An analysis of the economics and greenhouse gas impact of Marinus Link and Battery of the Nation: 2021 update

A report prepared for the Bob Brown Foundation

Professor Bruce Mountain

October 2021

Figure 2. Analysis of rolling average Residual Demand in Step Change scenario

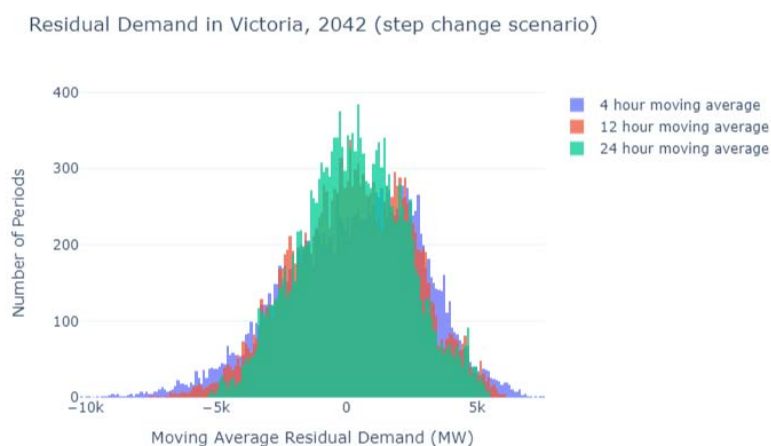
On (b), we have analysed the Residual Demand rolling averages under AEMO’s Step Change scenario and using Development Path 2 (the only Development Path under which neither Marinus 1 nor Marinus 2 are developed). The result of this analysis is shown in the histogram in Figure 2 below.

Figure 2 shows a similar distribution of the 4, 12 and 24 hour rolling average Residual Demands in 2042. It is a similar distribution as we observe for the Central Scenario, but using the Step Change scenario and assuming Development Path 2. When we overlay the total amount of the dispatchable generation and storage in Victoria in the Step Change scenario that does not include Marinus (Development Path 2) i.e. 9,976 MW, based on AEMO’s ISP projections we see that there is even less chance of the Residual Demand not being met than there is in the Central Scenario.

Figure 3. CSIRO Gencost 2021 storage capital costs, stated per kWh of duration

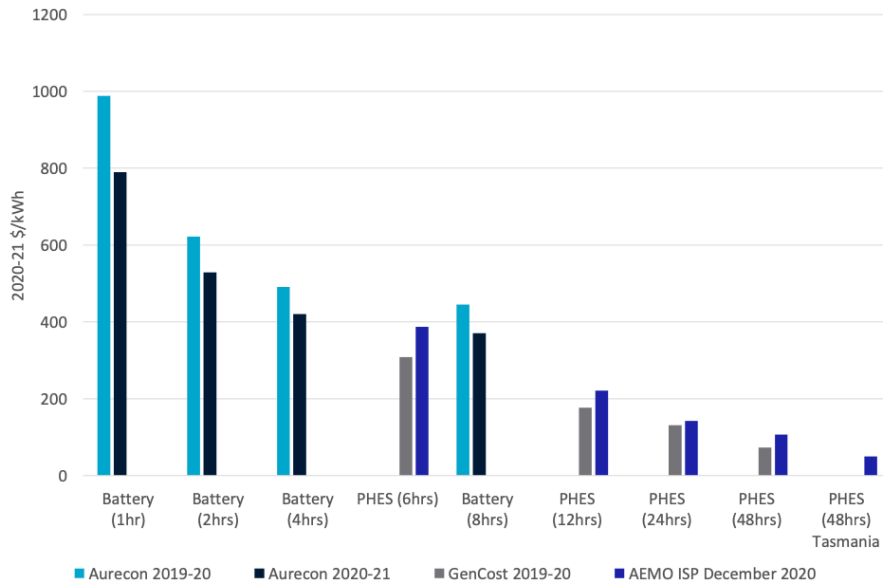
TasNetworks cites a chart (reproduced below) from CSIRO's Gencost 2021 report⁸ to support this claim.

TasNetworks seems to have misunderstood the information in CSIRO's chart. This chart simply expresses capital costs (\$ per kWh of storage duration) as a function of the duration of each storage type (i.e. how long the storage is capable of operating at its rated

Using TasNet’s logic, the chart presented in this way would suggest the opposite of their conclusion – i.e. that short duration storage is more “cost effective” than long duration storage. But this would be wrong the conclusion to draw from this, for the same reason that TasNetwork’s conclusion is wrong. It is impossible to draw any conclusion on cost-effectiveness from an analysis of capital costs alone. Rather “cost effectiveness” is a function of the unit cost of production for the market in which the technology competes. Its measurement requires information on capital costs, operating costs, asset life, residual value and utilisation. Conclusions on “cost effectiveness”, as TasNetworks has done that are based on just one of these four variables are not plausible.

Figure 4. CSIRO Gencost capital cost stated per kW of storage capacity

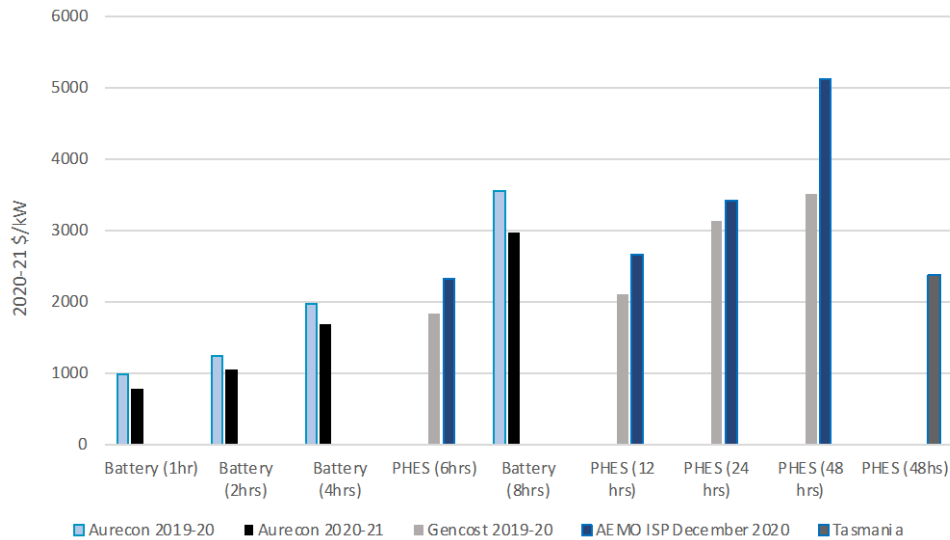
capacity). The chart can be re-stated in \$/kW simply by multiplying the capital cost per kW by the storage duration (indeed CSIRO did the reverse of this to generate the chart). The re-stated chart is shown in Figure 3 below.
